UNITED STATES
DEPARTMENT OF THE INTERIOR
BUREAU OF LAND MANAGEMENT

SUNDRY NOTICES AND REPORTS ON WELLS
Do not use this form for proposals to drill or to re-enter an abandoned well. Use Form 3160-3 (APD) for such proposals.

8. Well Name and No. HAWK 35 FED/201H

EOG respectfully requests an amendment to our approved APD for this well to reflect the following changes:

Revised Wellbore A:

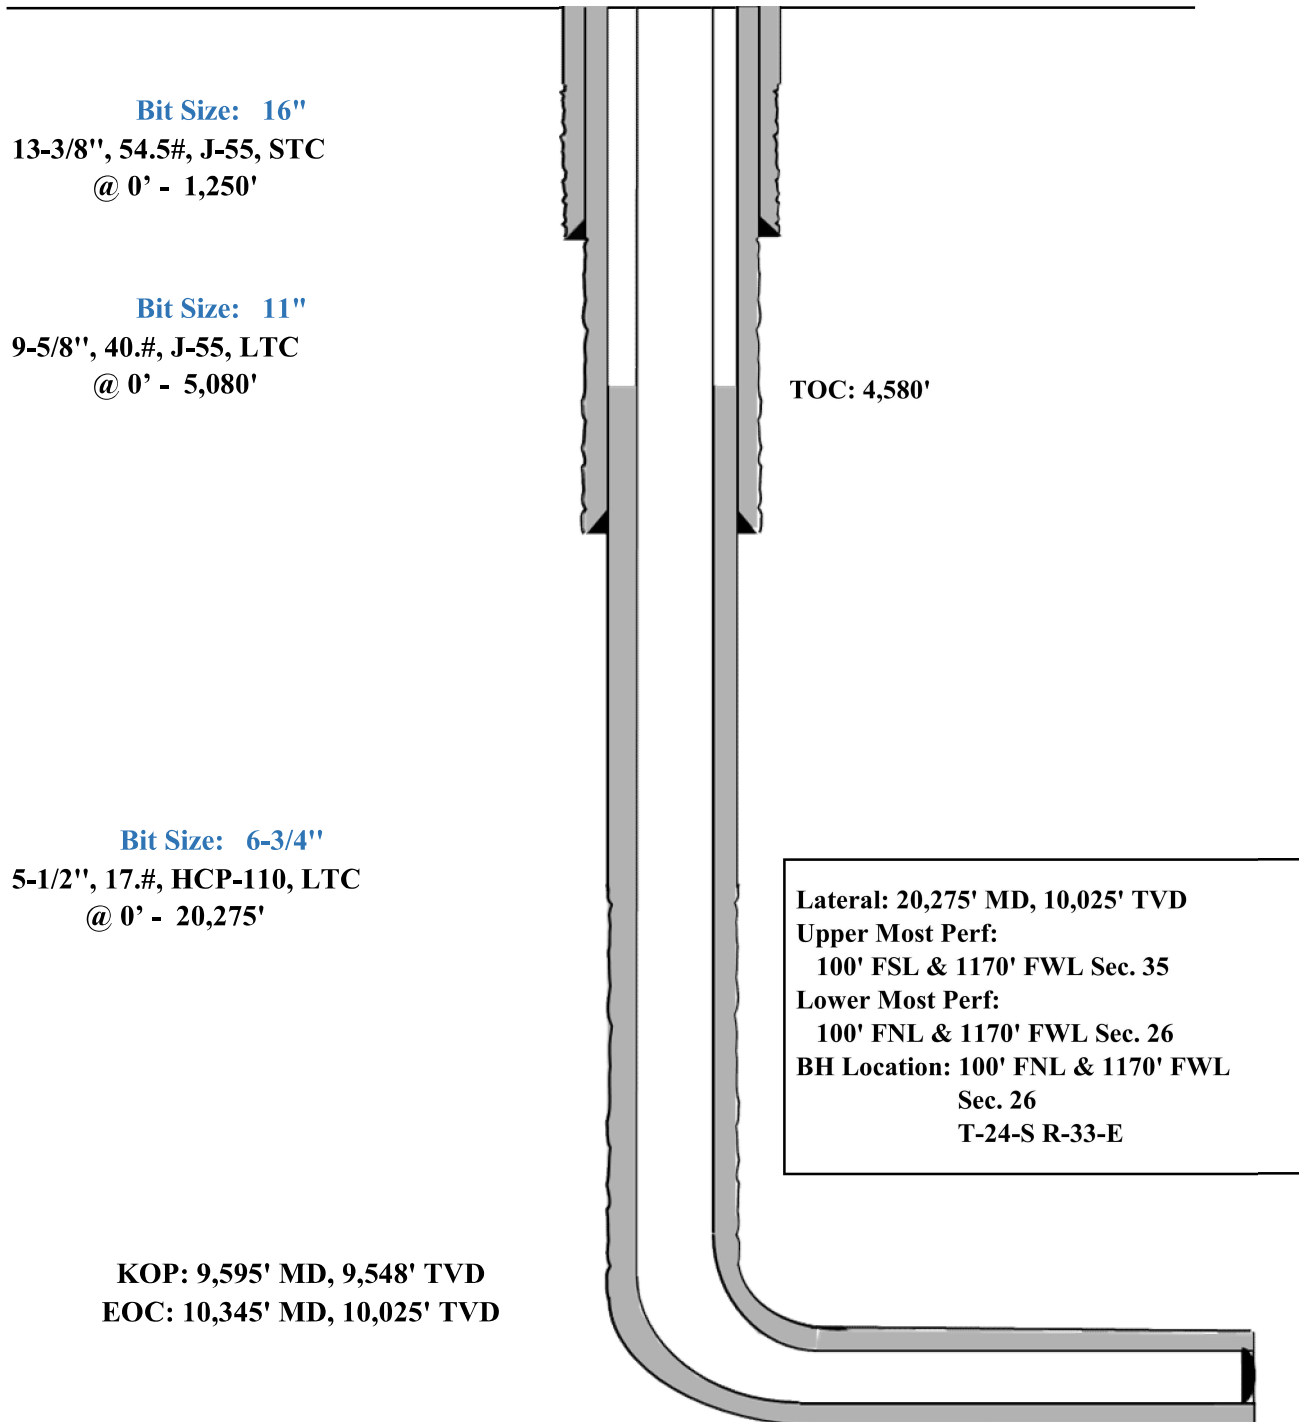
Update casing and cement program to current design.

Hole Size	Interval MD		Interval TVD		Csg OD	Weight	Grade	Conn
	From (ft)	To (ft)	From (ft)	To (ft)				
16"	0	1,250	0	1,250	13-3/8"	54.5#	J-55	STC
11"	0	4,049	0	4,000	9-5/8"	40#	J-55	LTC
6-3/4"	0	20,275	4,000	10,025	5-1/2"	17#	HCP-110	LTC

Proposed 11" Hole with 9.625" 40# J55/HCK55 LTC Casing

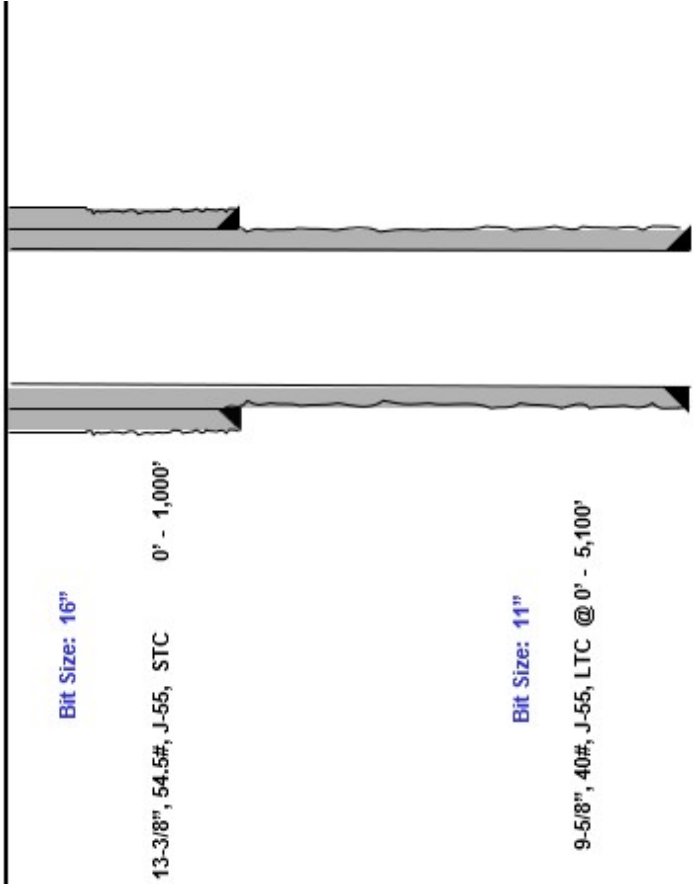
- 11" Bit + 0.52" Average hole enlargement = 11.52" Hole Size
 - 0.9475" Clearance to casing OD
$$= \frac{11.52 - 9.625}{2}$$
 - 0.4475" Clearance to coupling OD
$$= \frac{11.52 - 10.625}{2}$$
- Previous Shoe – 13.375" 54.5# J55 STC
 - 0.995" Clearance to coupling OD (~1,200' overlap)
$$= \frac{12.615 - 10.625}{2}$$

CASING SET POINTS HAVE BEEN ALTERED IN THE COA AND IS DIFFERENT FROM THE ATTACHED DRILL PLAN. DISCUSSED AND CLARIFIED CHANGE IN INTERMEDIATE SET DEPTH WITH OPERATOR TO ACHIEVE CONGRUENCE BETWEEN DESIGN A AND DESIGN B SET POINTS.

2. The **9-5/8** inch intermediate casing shall be set at approximately **5,080** feet TVD. **Cement excess < 25% CFO recommendation. Please review cement volumes to achieve below mentioned tie-back.** The minimum required fill of cement behind the **9-5/8** inch intermediate casing is:

Proposed 9.875" Hole with 8.625" 32# J55/P110 BTC-SC Casing

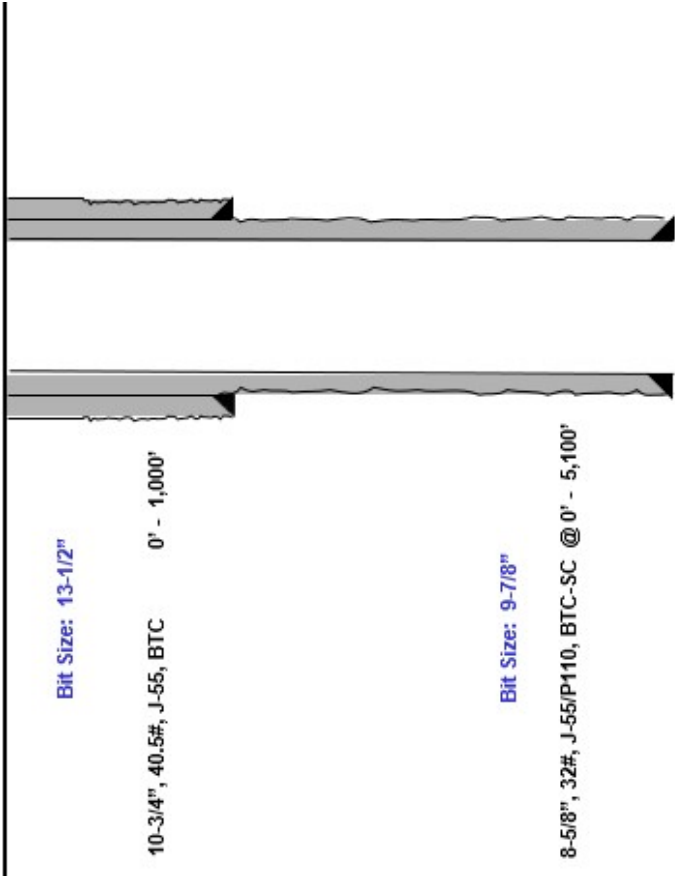
- 9.875" Bit + 0.42" Average hole enlargement = 10.295" Hole Size
 - 0.835" Clearance to casing OD
$$= \frac{10.295 - 8.625}{2}$$
 - 0.585" Clearance to coupling OD
$$= \frac{10.295 - 9.125}{2}$$
- Previous Shoe – 10.75" 40.5# J55 STC
 - 0.4625" Clearance to coupling OD (~1,200' overlap)
$$= \frac{10.05 - 9.125}{2}$$
